## Questions regarding intakes and tunnels as presented

Nicole S. Suard, Esq. for Snug Harbor Resorts, LLC

N. Suard, Esq. for Snug Harbor Resorts, LLC  
re: tunnel construction impacts

Figure 1: TDF Project Location

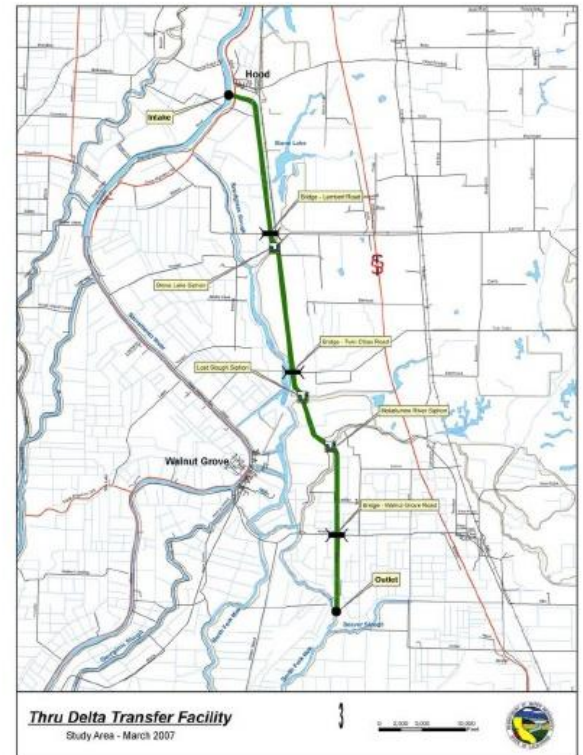
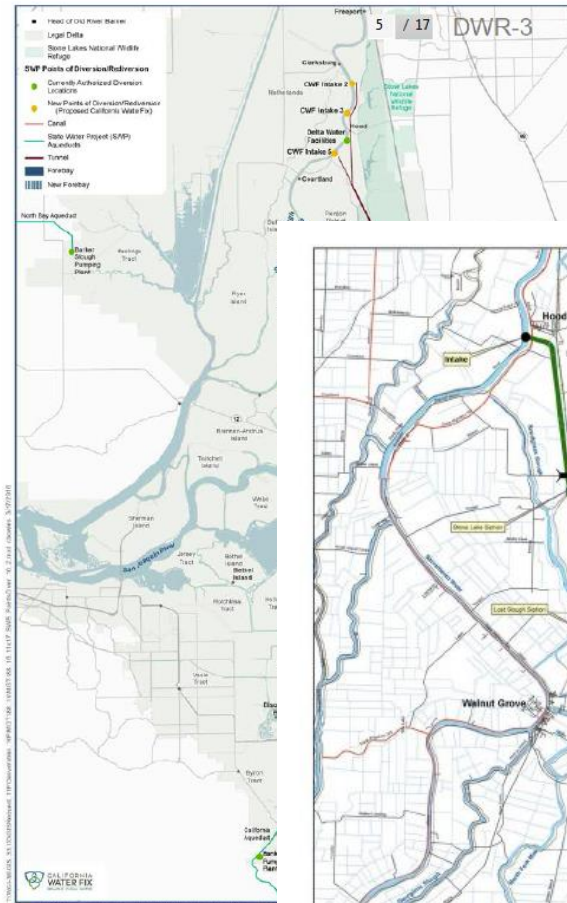
1. Existing authorized point of diversion is shown on the map as between intakes 2 and 3. Is that a 1,350 cfs capacity intake? Is it anticipated that when there is sufficient flow on the Sacramento River the full 10,350 cfs under all four permits would be taken from the Sacramento River?

## PHYSICAL COMPONENTS OF THE PROJECT

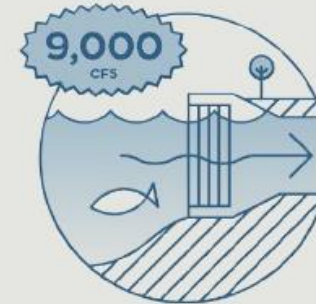
1. 1 cfs = 1.98 acre feet per day estimated.  $9000 \text{ cfs} \times 1.98 = 17,820 \text{ af per day}$ , which equals 6,504,300 acre feet per year, so why the average yield of 4.9 million acre-feet? Does it take diversion of 6.5 maf to deliver 4.9 maf?
2. Will there be overflow or pressure relief valves and if so where does that water go? Is MAXIMUM capacity for each intake 3000 cfs or is each designed to be adaptable to accept extra capacity? What is the diameter of each smaller tunnel or pipes, and the total number of tunnels or pipes, from each intake structure to the 40 foot tunnels?
3. Will those smaller tunnels or pipes be located at the bottom of the river, mid-river or near the surface?
4. What is the capacity of each 40 foot tunnel? In cfs and in acre feet?

### MAIN TUNNELS

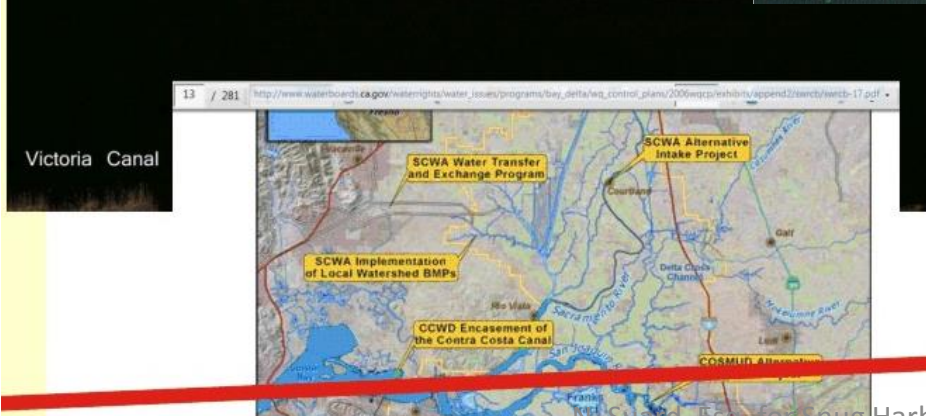
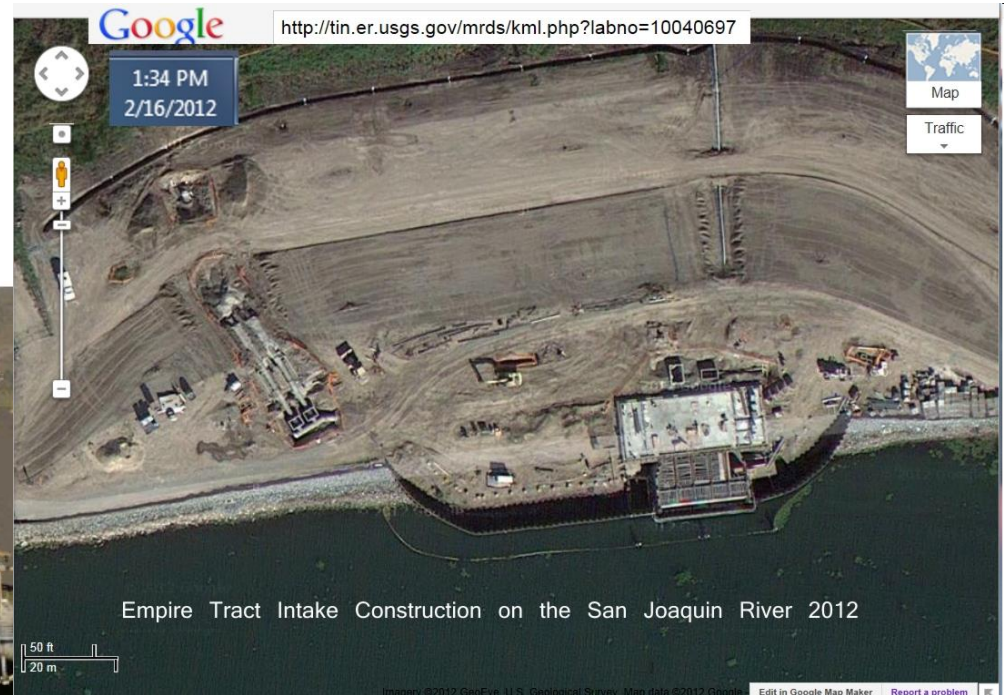
Tunnels and shafts have already been constructed in the Delta region. Were these projects reviewed to give the engineering team an idea of what they might expect to happen?

# Where is a detailed side profile for the intakes and tunnels?

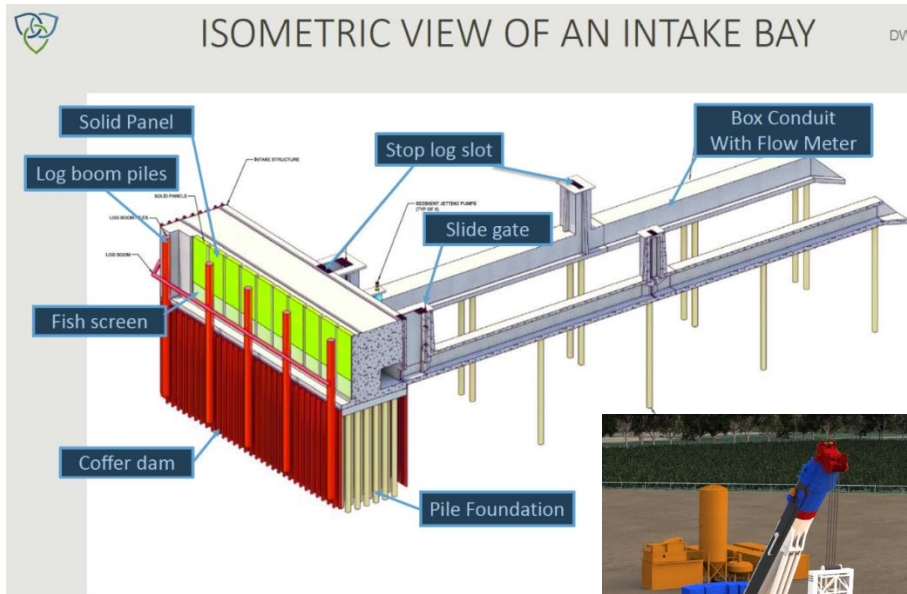
Compared to the existing HWY 160, How much higher, in feet, will the Profile of the intake structure be and How much higher will be the new levee And HWY 160?

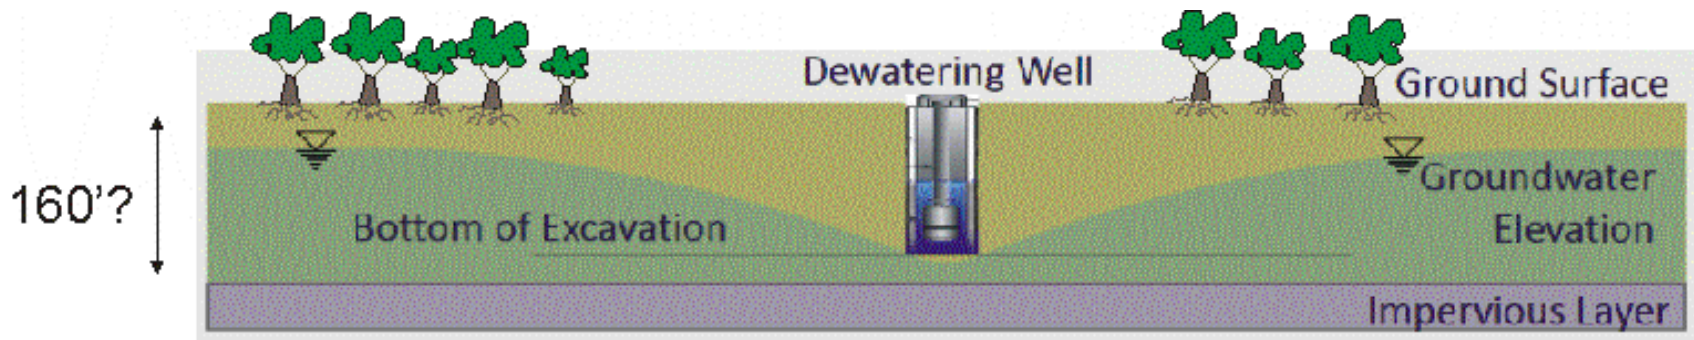
Does water drop 150 feet into tunnels, get pumped up to forebay then dropped again 150 feet or is the tunnel shallow at the intakes and gradually slopes downward to create gravity feed?

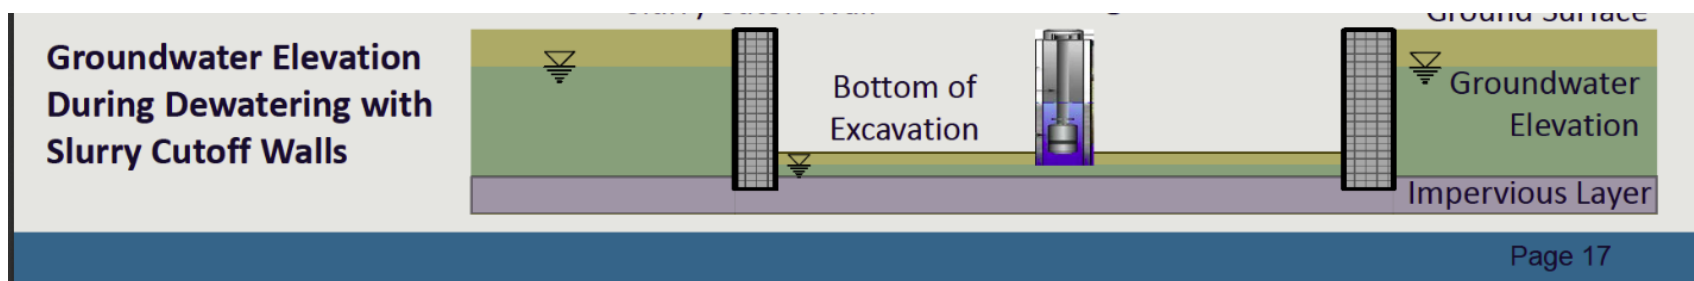
Dewatering will potentially eliminate the water source for area trees which have relied on groundwater during dry periods for their entire existence. How long will the trees in the area survive without root access to groundwater? Or is there a plan to water the trees during the time period of dewatering the ground?

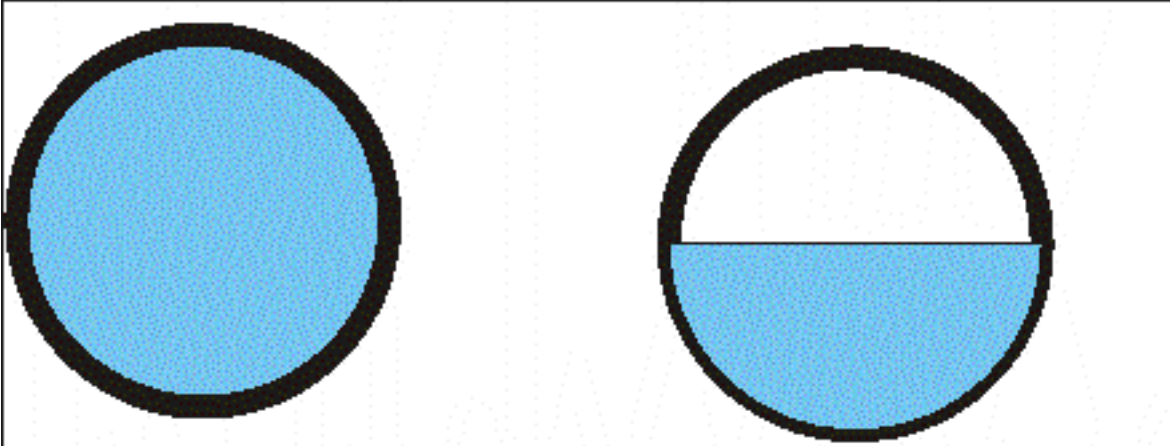
- What are the assumed flood effects from pilings during the “temporary” 10 years of construction?
- What do you do with the silt from the sediment drying bays? If you dump it back into the Sacramento River, that affects everyone’s water quality downriver!
- What is the expected noise factor during construction?
- Will there be backflow prevention valves and/or pressure relief valves?

Figure 4-21. Plan View of the Proposed Gate Structure at Threemile Slough

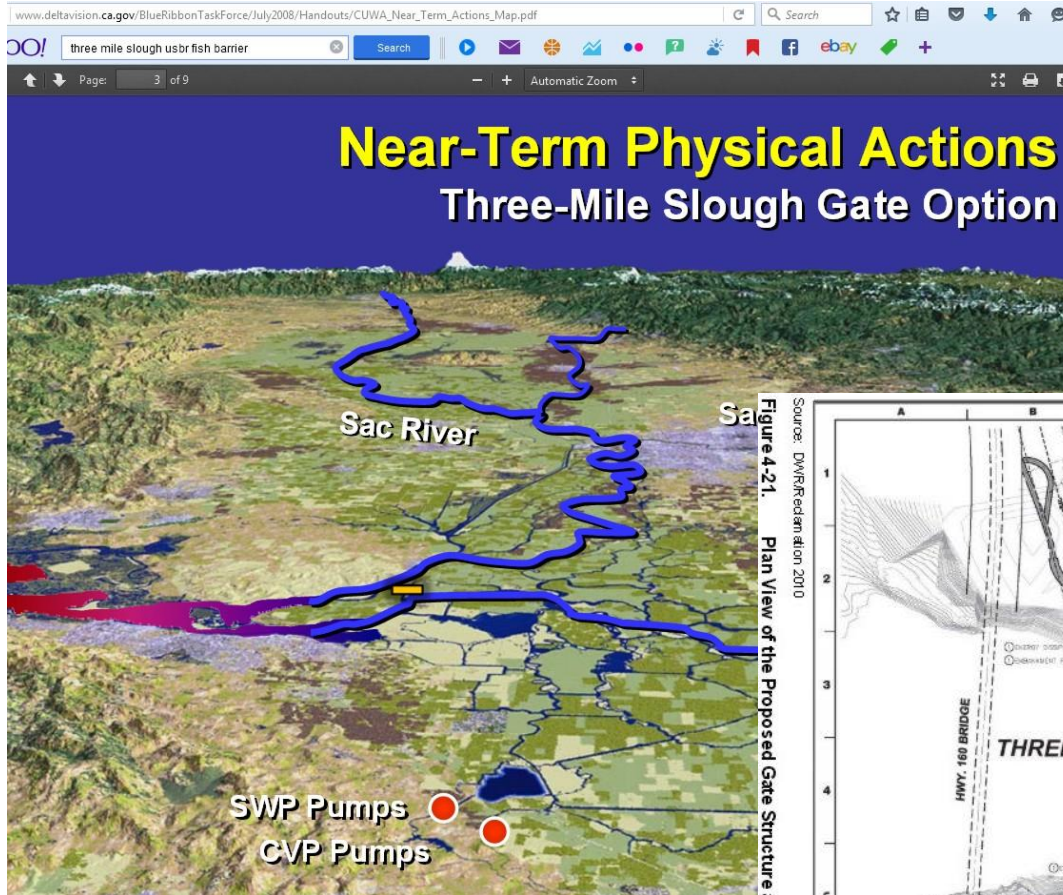
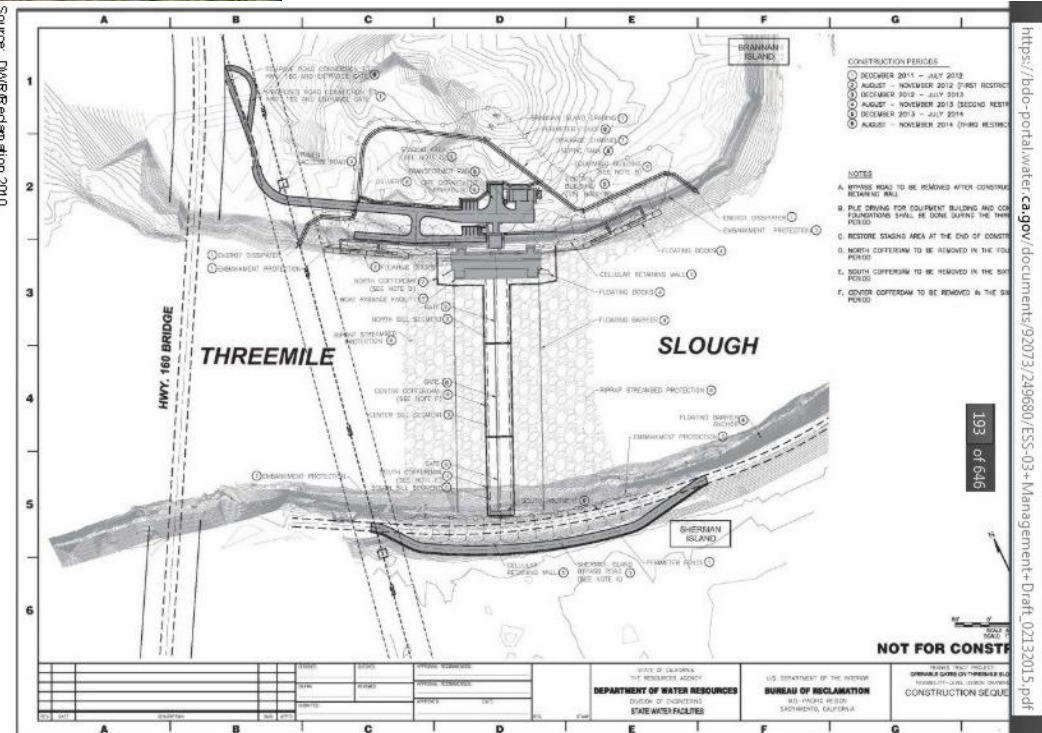
USBR (2015) already went through the process to install flow and fish barrier on 3-Mile Slough. Was this considered in the design and location of the tunnels? (2008 Blue Ribbon Task Force presentation & 2016 USBR

Figure 2-2  
Illustration of Bottom-Hinged Gate Operation

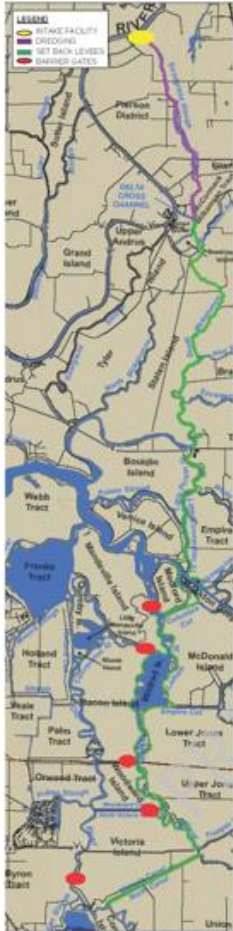
Have these types of barriers been installed anywhere in the Delta? If not, why not try it instead of permanent barrier at Head of Old River?
